# VOLLMER ROAD (NORTH)

## STREET IMPROVEMENT PLAN

FEBRUARY 2022

**VOLLMER ROAD (NORTH)**  
COVER SHEET

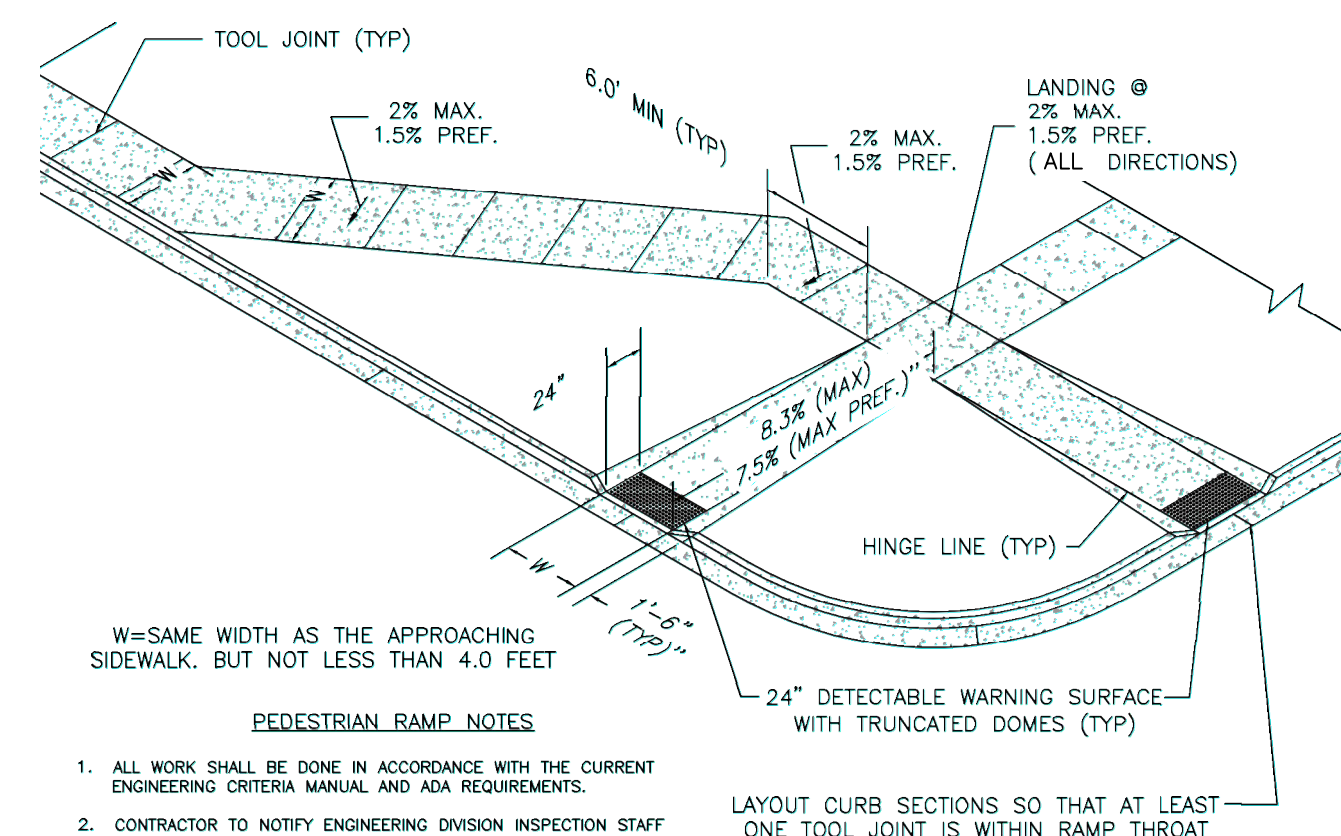
Unresolved:  
Include detail for sawcut and mill/overlay

<b>VOLLMER ROAD (NORTH)</b>	<b>SIGNAGE &amp; STRIPING</b>
SHEET 10 OF 16	JOB NO. 25188.00

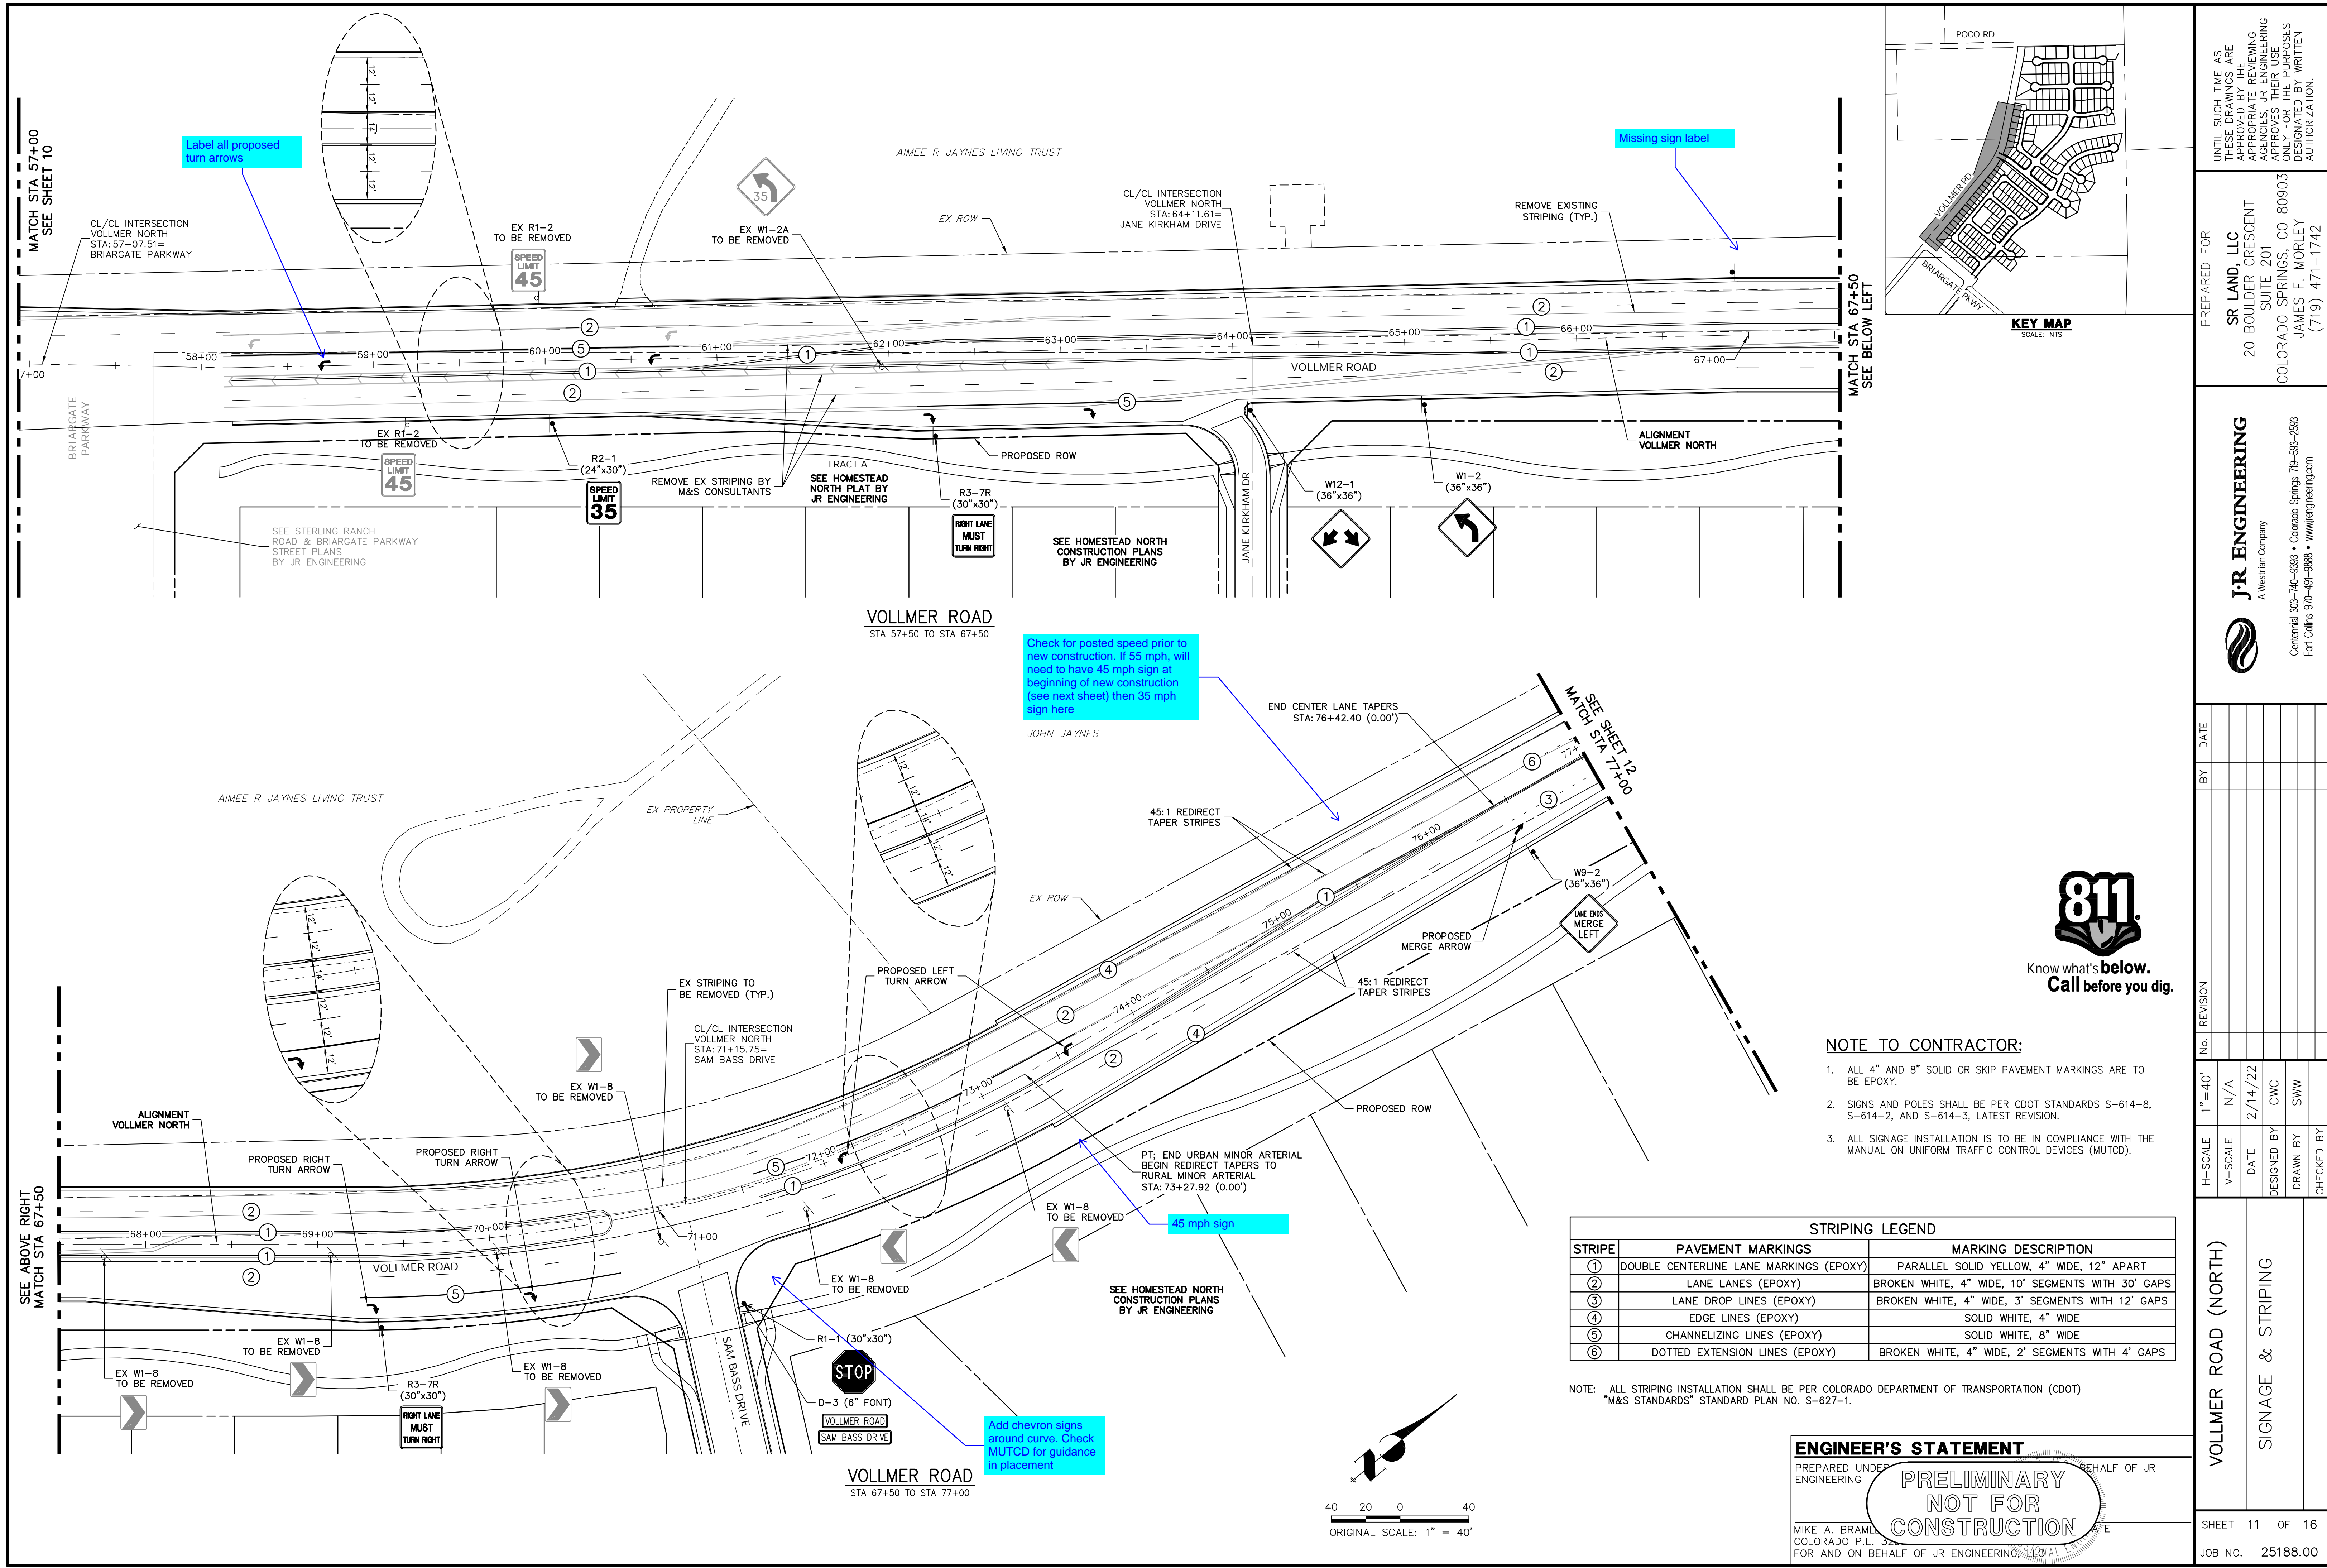
Label all proposed turn arrows

Missing sign label

Check for posted speed prior to new construction. If 55 mph, will need to have 45 mph sign at beginning of new construction (see next sheet) then 35 mph sign here

45 mph sign

Add chevron signs around curve. Check MUTCD for guidance in placement

SHEET 11 OF 16  
JOB NO. 25188.00

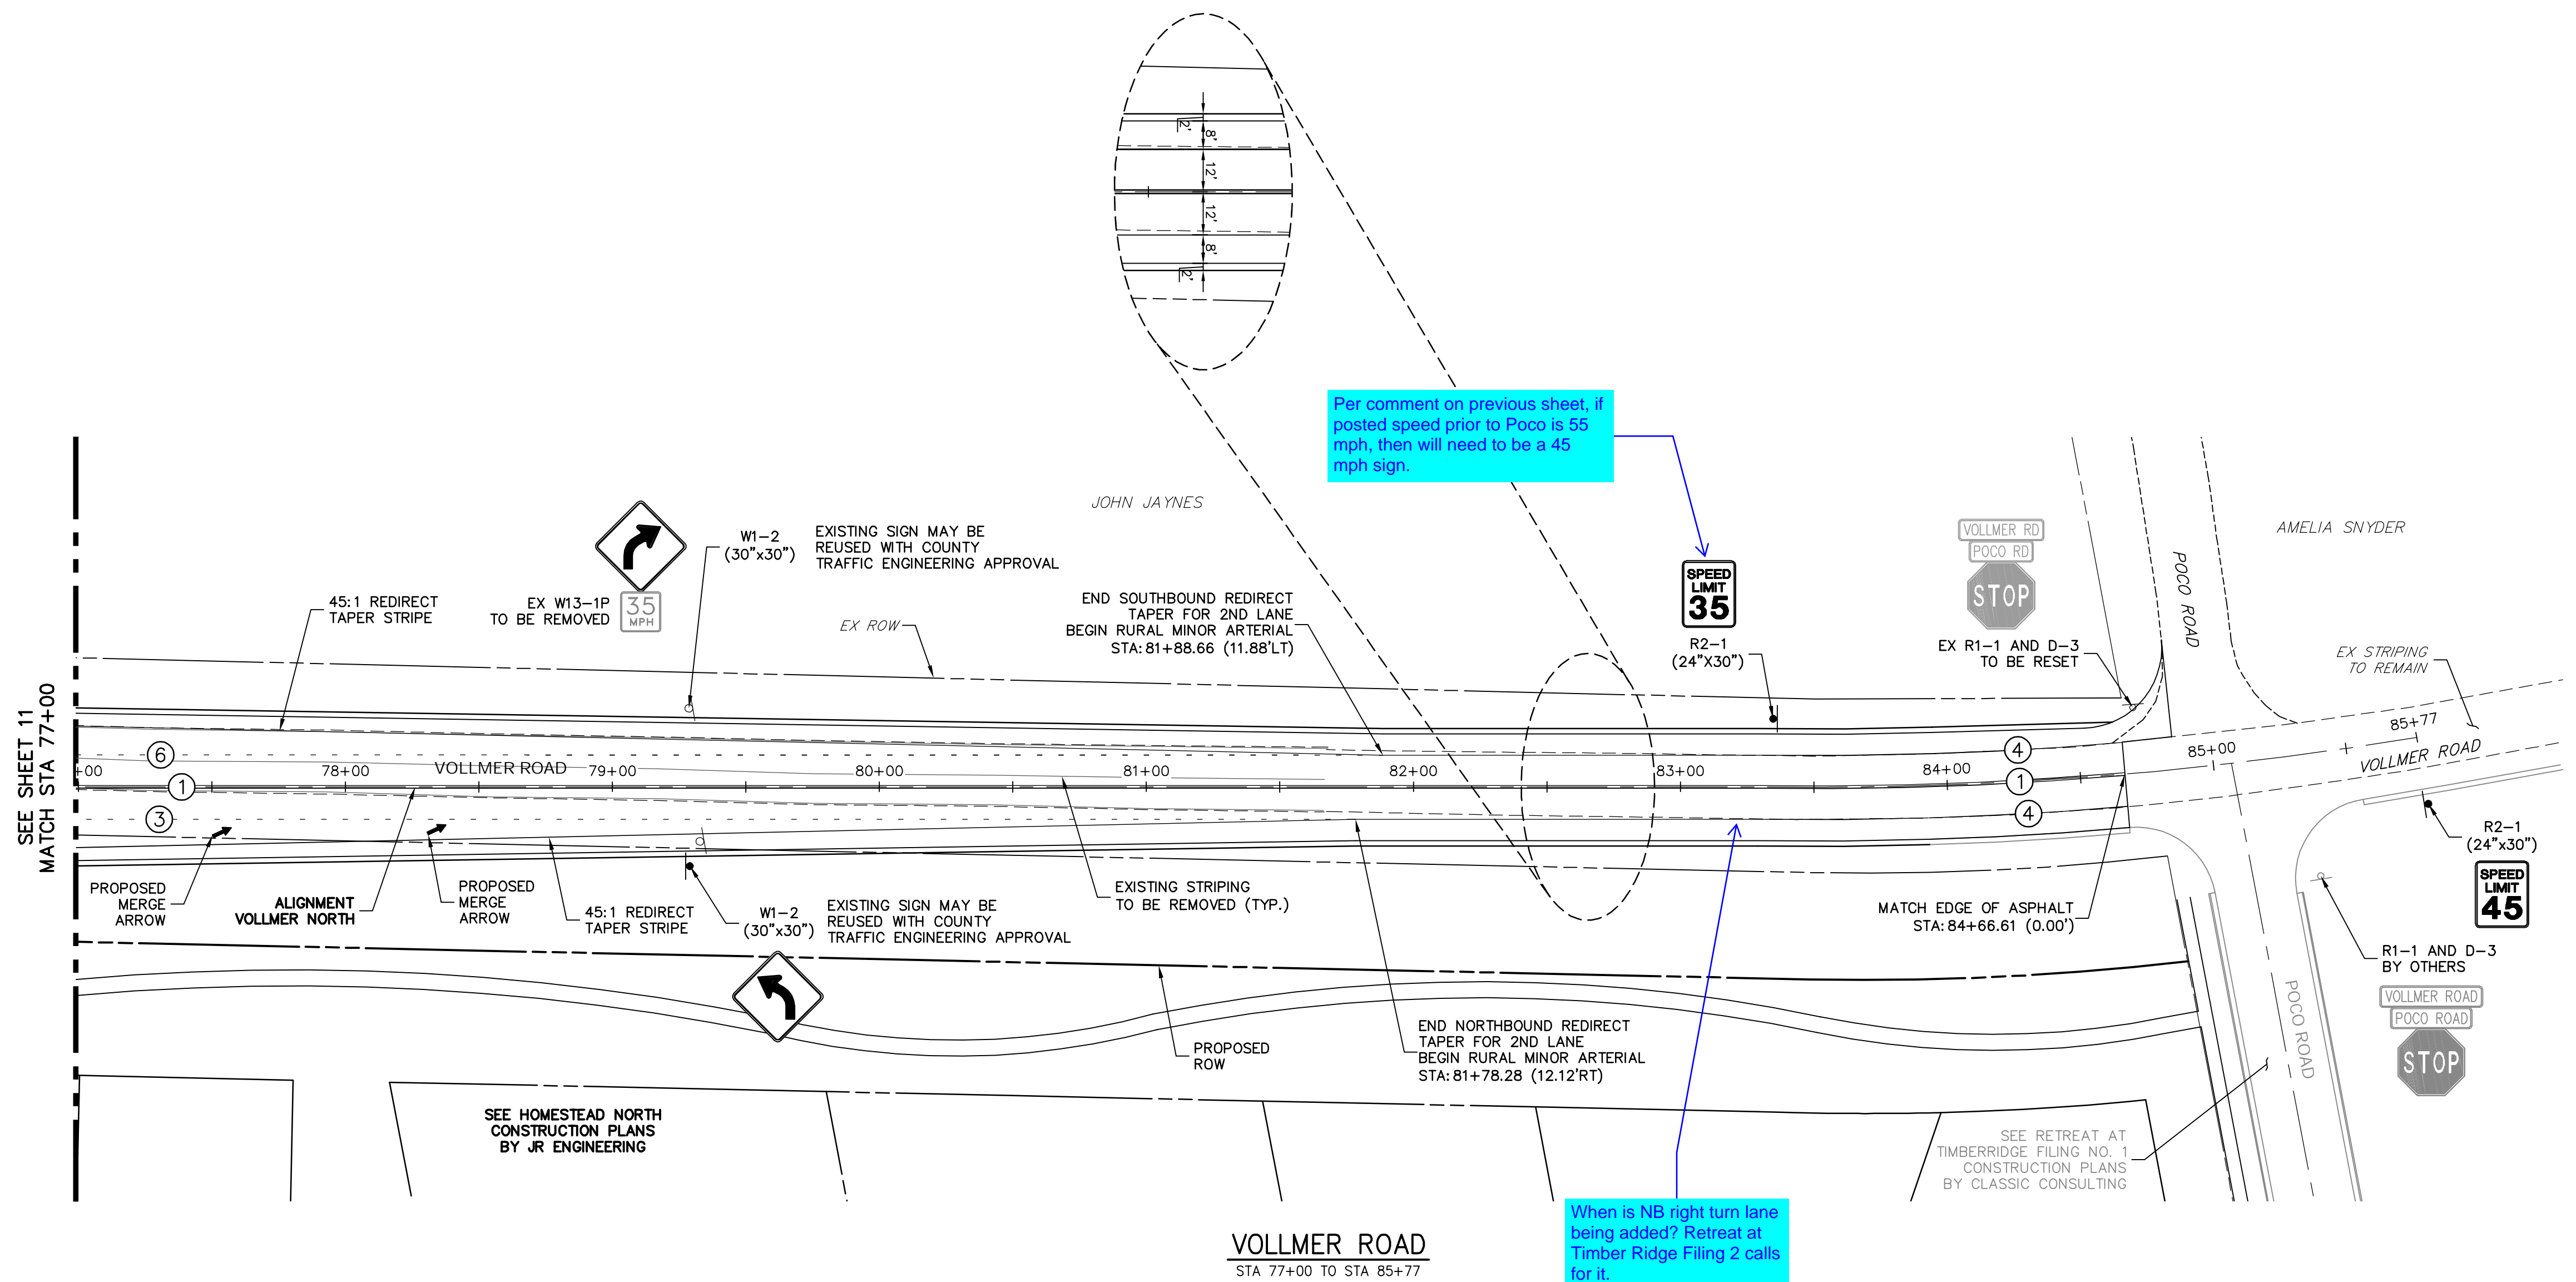
Per comment on previous sheet, if posted speed prior to Poco is 55 mph, then will need to be a 45 mph sign.

When is NB right turn lane being added? Retreat at Timber Ridge Filing 2 calls for it.
